Co3273 – Weston ER P23-1(230)

ADDENDUM #2

REVISED: Plan Sheets 2 and 27.

SHEET 2 OF 40

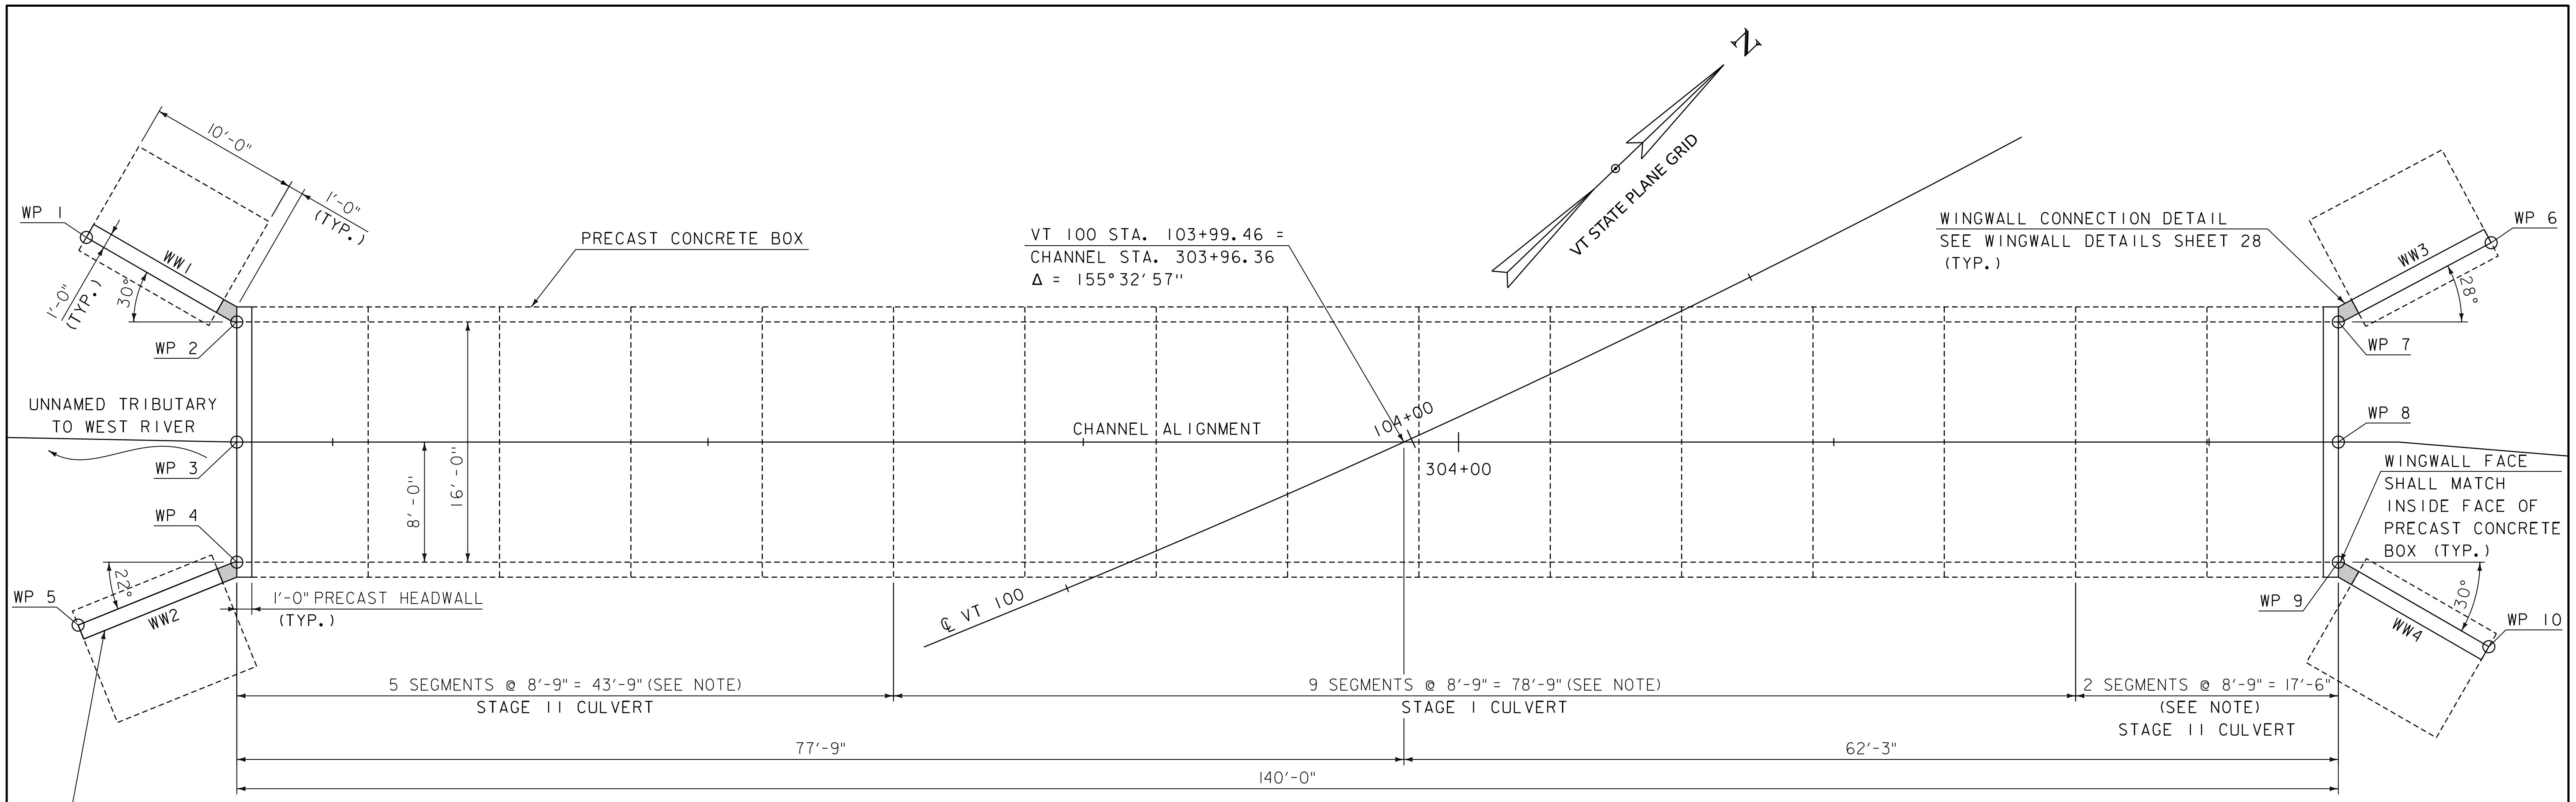
ADDENDUM	REVISION	DATE	DESCRIPTION	BY
	1	06-09-2026	ADDED UNITS FOR FLOW FREQUENCY	CSB

FLOW FREQUENCY:	FLOW:	HEADWATER ELEVATION:	OUTLET VELOCITY:
AEP 50% (Q2):	76 CFS	1291.09-FT	8.5-FPS
AEP 10% (Q10):	170 CFS	1291.73-FT	10.4-FPS
AEP 4% (Q25):	230 CFS	1292.06-FT	11.2-FPS
AEP 2% (Q50):	290 CFS	1292.37-FT	12.0-FPS
AEP 1% (Q100):	350 CFS	1292.65-FT	12.7-FPS

JOINT DETAIL

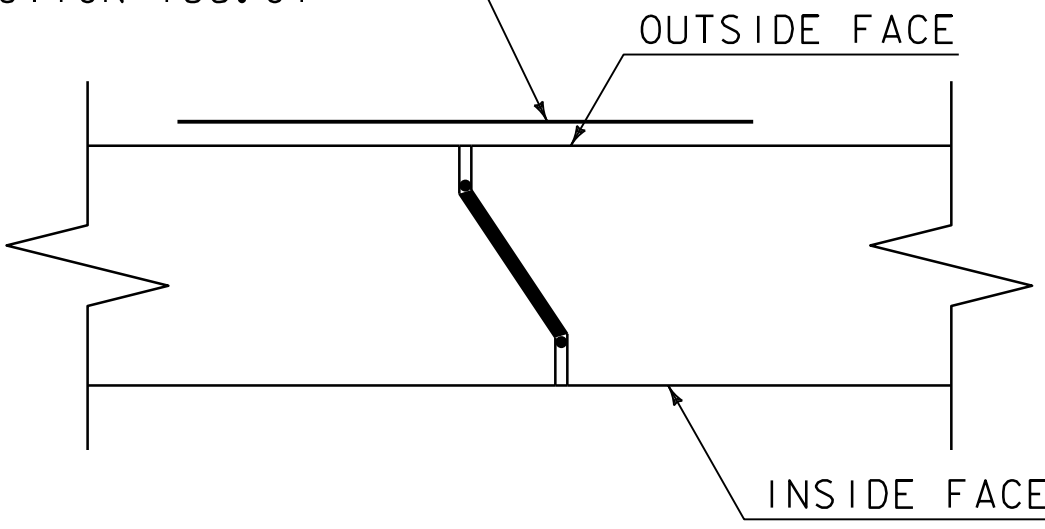
ADDENDUM	REVISION	DATE	DESCRIPTION	BY
2	1	06-09-2026	ADDED JOINT DETAIL NOTE	CSB

NOTE:
JOINT IN BOX CULVERT WALL SHOWN. JOINT IN BOX CULVERT SLAB SIMILAR, EXCEPT WATERPROOFING MEMBRANE SYSTEM SHALL COVER THE ENTIRE TOP OF THE SLAB.
